# Intel<sup>®</sup> Pentium<sup>®</sup> III Processor Specification Update

Release Date: March 2002

Order Number: 244453-039

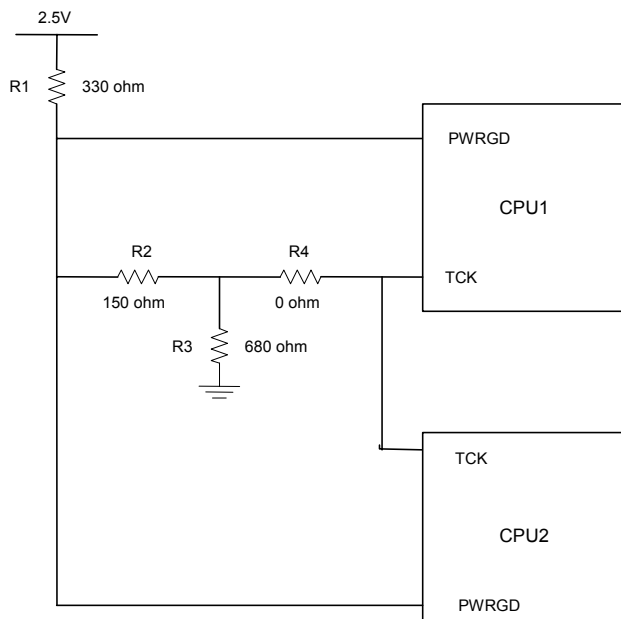
**Problem:** The internal control register bit responsible for operation of the Thermtrip circuit functionality may power up in a non-initialized state. As a result, THERMTRIP# may be incorrectly asserted during de-assertion of RESET# at nominal operating temperatures. When THERMTRIP# is asserted as a result of this erratum, the processor may shut down internally and stop execution but in few cases continue to execute.

**Implication:** This issue can lead to intermittent system power-on boot failures. The occurrence and repeatability of failures is system dependent, however all systems and processors are susceptible to failure. In addition, the processor may fail to stop execution during the event of a valid THERMTRIP# assertion resulting in the potential for permanent processor damage.

**Workaround:** To prevent the risk of power-on boot failures or catastrophic thermal failures, a platform workaround is required. The system must provide a rising edge on the TCK signal during the power-on sequence that meets all of the following requirements:

- Rising edge occurs after Vcc\_core is valid and stable
- Rising edge occurs before or at the de-assertion of RESET#
- Rising edge occurs after all Vref input signals are at valid voltage levels
- TCK input meets the Vih min and max spec as mentioned in EMTS

**Figure 1: Noise Estimation**

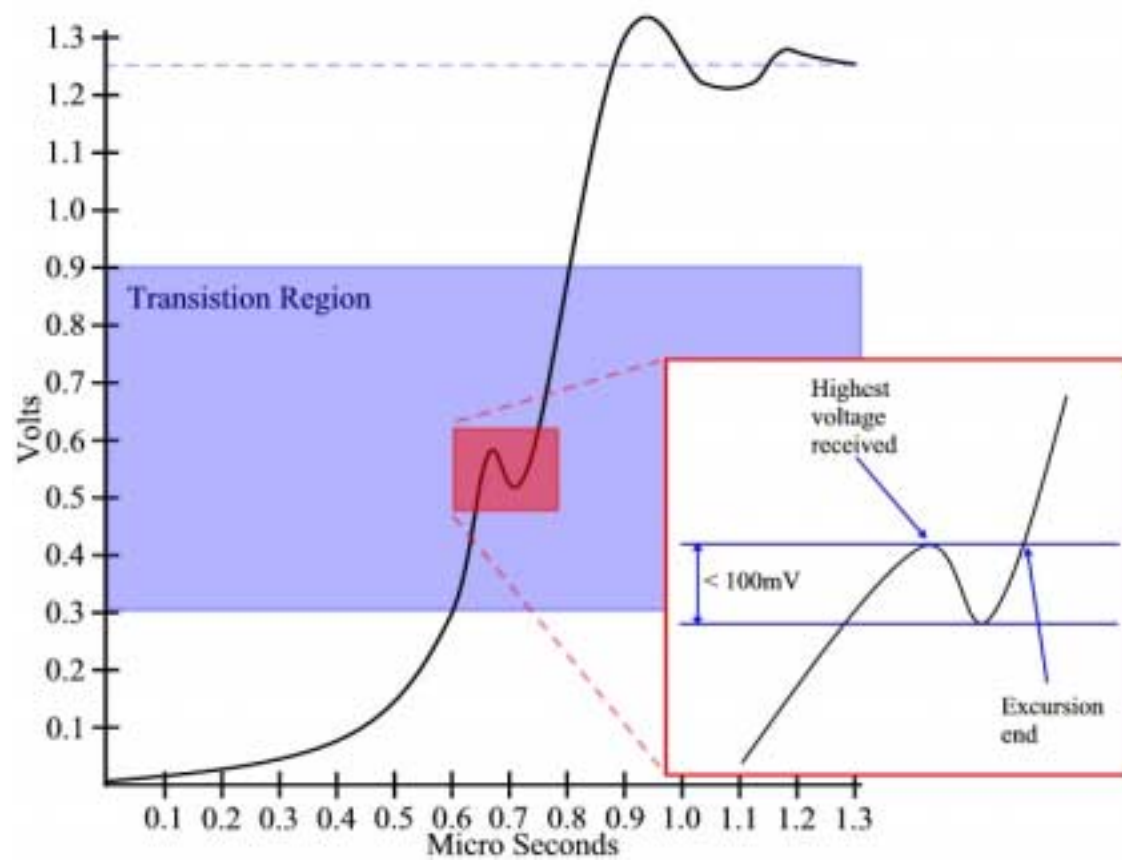
The signal quality of the VTT\_PWRGD signal is critical to the correct operation of the processor. Every effort should be made to ensure this signal is monotonic in the transition region. If noise or glitches are present on this signal, it must be kept to less than 100mV of a voltage drop from the highest voltage level received to that point. This glitch must remain less than 100mV until the excursion ends by the voltage returning to the highest voltage previously received. Please see Figure 1 for an example graph of this situation and requirements.

This change will be incorporated into the next revision of the Datasheet.
